RE: Remarkables Ski Area Upgrades and Doolans Expansion – Response to Landscape Feedback

PEER REVIEW MEMORANDUM REGARDING LANDSCAPE AND VISUAL EFFECTS ASSESSMENT

DOC Memorandum on NZSki Landscape Effects Assessment

REMARKABLES SKI DOOLANS EXTENSION

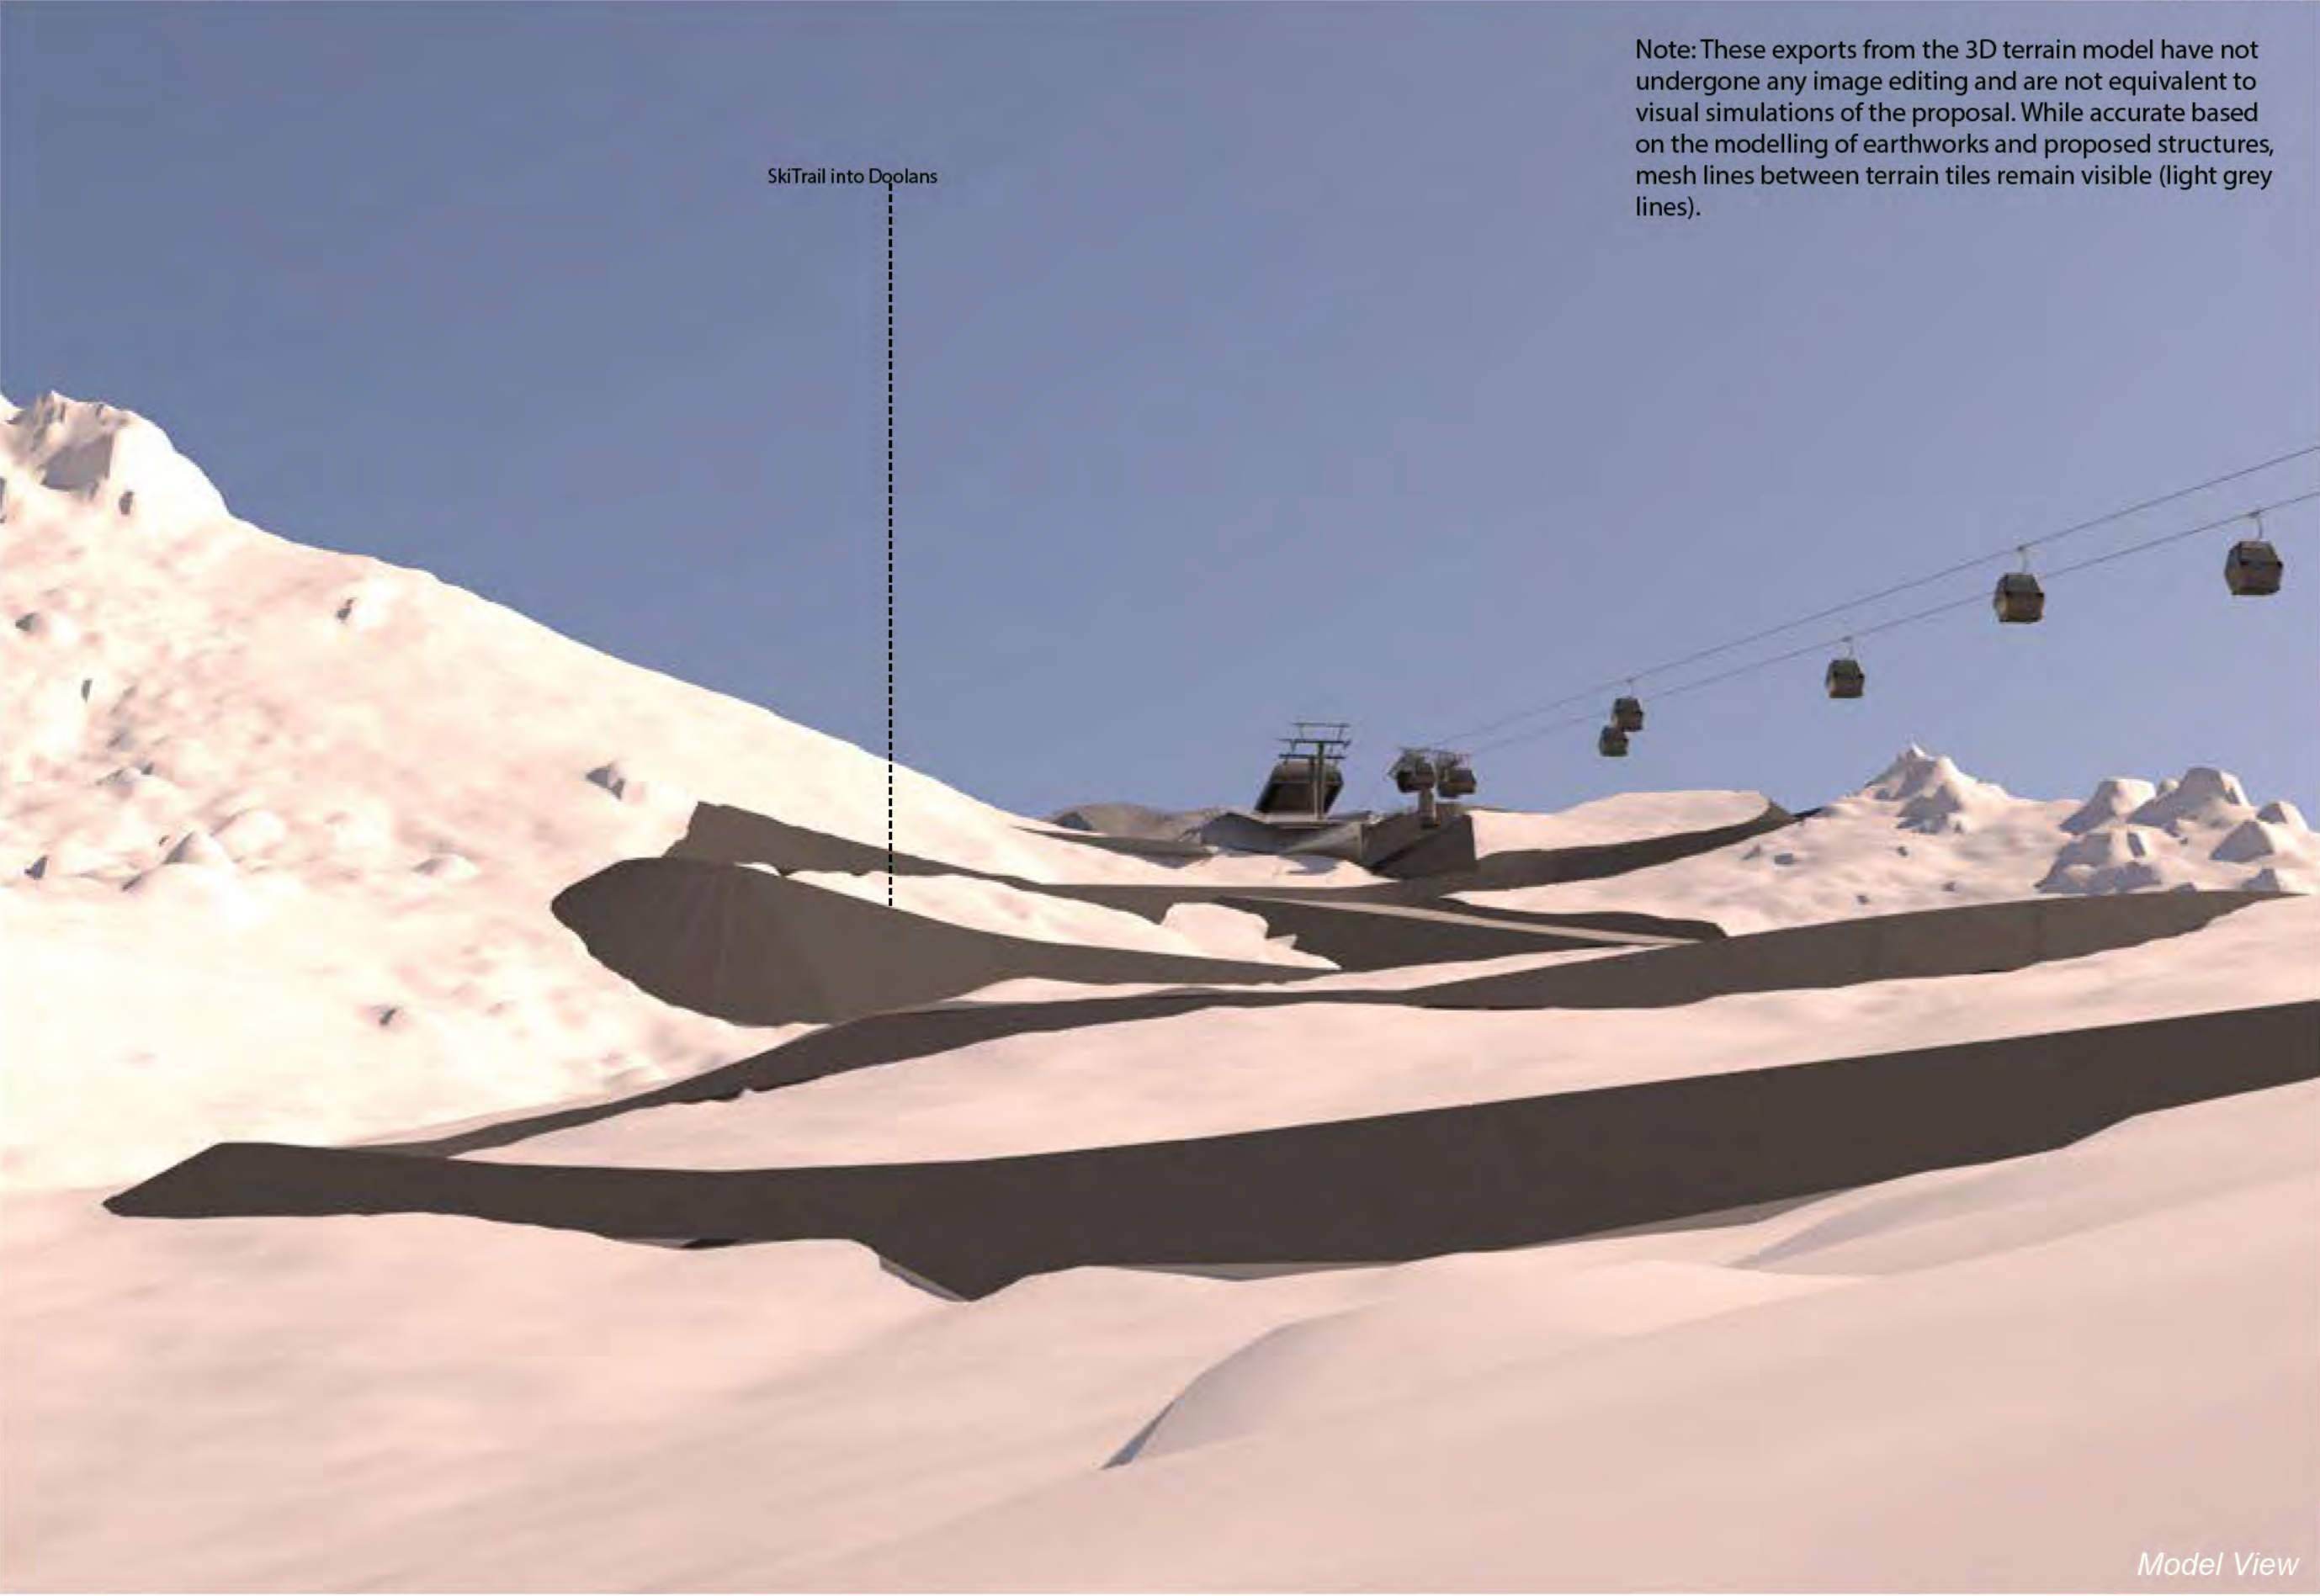
2. NZSki to provide views of the proposed mid-station in relation to the surrounding landform and landscape context.

19. The mapping in the 6 May 2026 B-031.1 Remarkables Ski Area Upgrade and Doolans Expansion Landscape Graphics (Figures 1, 2 and 4) is at a scale / level of detail where it is difficult to see where the proposed gondola mid-station is located. It is important that the various areas (QLD area and its mapped SASZ, the COD area, Rastus Burn Recreation Reserve and ridgeline) are accurately mapped along with the location of the mid-station building.

- > See attached Boffa Miskell memo and graphic supplement (**Attachment 3**)

The additional exports show both the mid station building and the earthworks required to establish the structure, including the proposed retaining walls and lift towers. In views within the ski field (see pages 1-10) the platform/retaining wall and lift tower will partially appear on the skyline, with the midstation structure itself largely out of view. For more distant views, the midstation will partially appear on the skyline (see visual simulation 3). However, in these views the structure is a comparatively small element.

On the Doolans side of the ridge the midstation is within a up to 10m high cut, but in nearby views from immediately below the structure (see Model view p.18) the mid station would protrude on the skyline. However, as shown in the ZTV, the mid station is obscured from substantial parts of the Doolans basin by intervening ridgelines. Pages 13-16 illustrate views of the mid station in views along the ridgeline to show the cut (Doolans side) and fill (Rastus Burn side) required to construct the platform. It is acknowledged that the visual effects of the mid station will be high when viewed within its immediate context along the ridge or from immediately below on the Doolans side. However, I maintain the view that visual effects of the mid station from the Rastus Burn side are mostly moderate, as the retaining wall partially obscures the structure in short-distance views and in long-distance views the structure is a relatively small element on a rocky ridgeline.
